Subject: Re: 423899 - Benicia PD - Encroachment Permit Application; 0424-NSV-0053

Per headquarters, the FHWA CA Division has expressed concerns about license plate readers in Interstate ROW and consequently, have paused their review of those EPE requests. The FHWA is working with the Caltrans team to collect data to determine whether to approve the placement of the readers

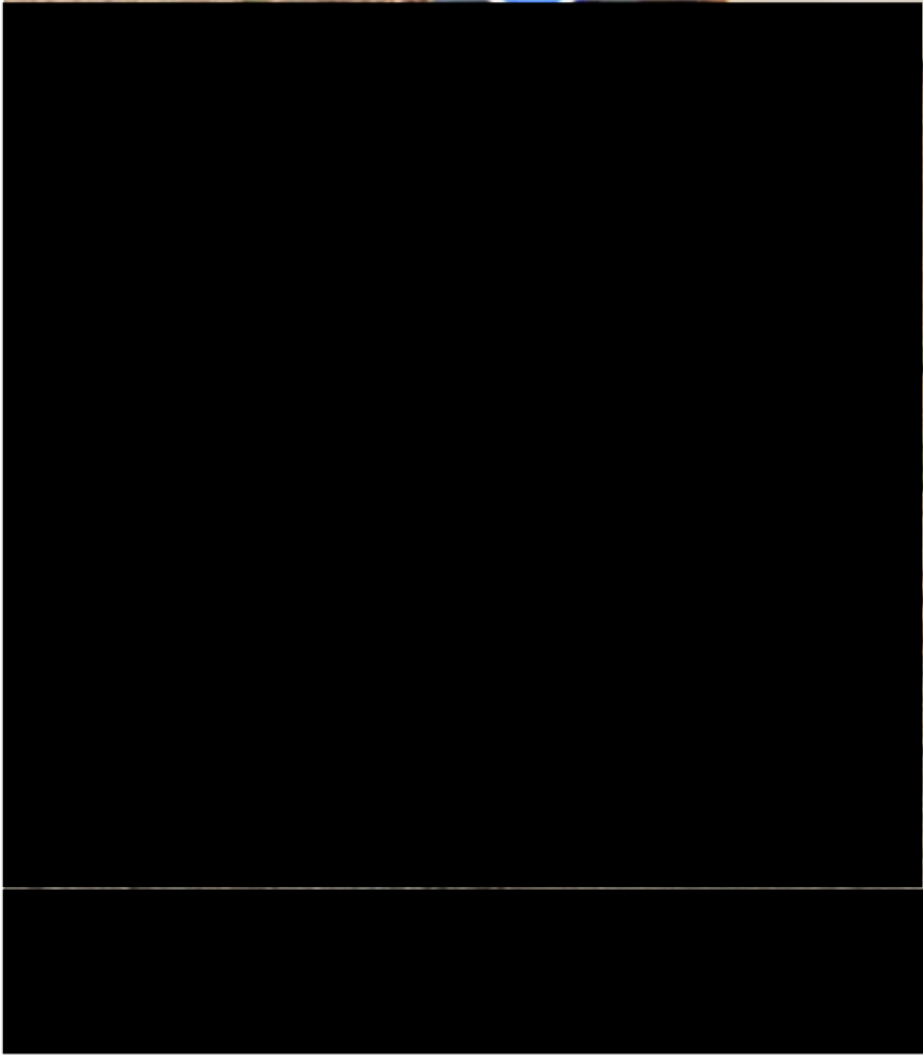
Please see the latest comments from our structural reviewer below and provide the requested information:

The submitted calcs (pages 5 and 10) assumed current Std Plan dimensions. However, it is my opinion that the existing pole is an older type.

Please provide **As-Built of the existing light pole** (see image below).

There is an aluminum identification tag on the existing pole.

And from that, one can determine:

- Year of the original construction and/or Year of Std Plans, and
- Pole Type.

Please provide the existing pole information and dimension or as-built for further review.
